RE: WESTCONNEX M4 EAST (SSI 6307) – NOTICE OF PUBLIC EXHIBITION.

STRATHFIELD COUNCIL SUBMISSION

WESTCONNEX M4 EAST APPLICATION NO SS1 6307 – ENVIRONMENTAL IMPACT STATEMENT (EIS)

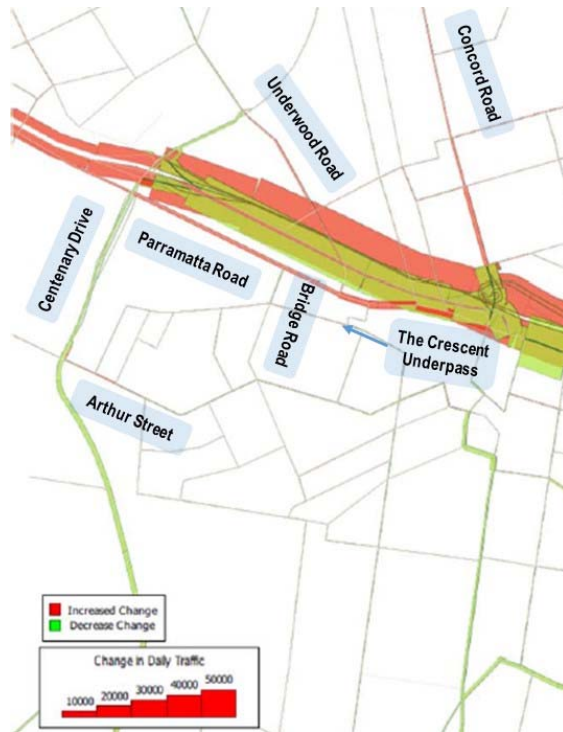
The traffic assessment coverage and methodology issues identified were:

- The coverage and methodology for the traffic impact assessment were insufficient to identify the level of additional traffic in residential streets in the study area. The strategic modelling was too coarse and the intersection modelling too limited to allow for identification of what WestConnex M4 East traffic would be drawn through residential streets in the impact review area. Mesoscopic modelling of the area north of Arthur Street, east of Centenary Avenue, south of Pomeroy Street and west of Concord Road would be needed to more sensitively determine these impacts; and
- The mitigation of the EIS-identified impacts at the George Street/Parramatta Road intersection have not been identified and there will be consequential impacts for local traffic in the impact assessment area, particularly for Parramatta Road intersections such as Underwood Road, Knight Street and Bridge Road.

Figure 5.2: Construction Access and Capacity Issues

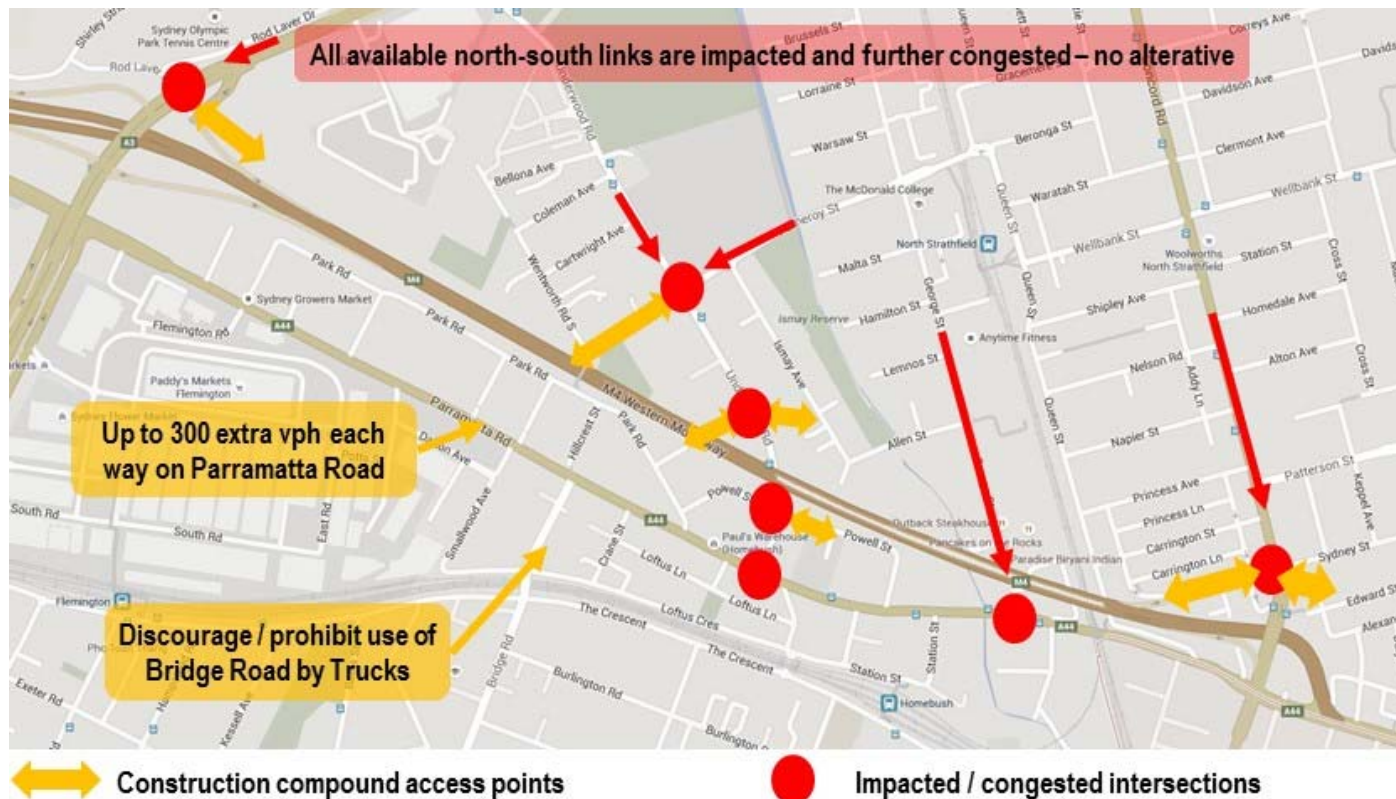
Delays to general traffic due to the construction traffic effects at the Short Street and Powell Street intersections may encourage traffic diversions to George Street, although it is recognised that its intersection with Parramatta Road would be similarly congested and hence be a deterrent to this alternative.

Figure 5.2 highlights these potential issues.

- Part of the mitigation to construction period impacts could include some temporary widening works in Underwood Road at the Powell Street and the Short Street compound site access intersections to separate turning vehicles from through vehicles, including management plans to address loss of on street parking due to these works.
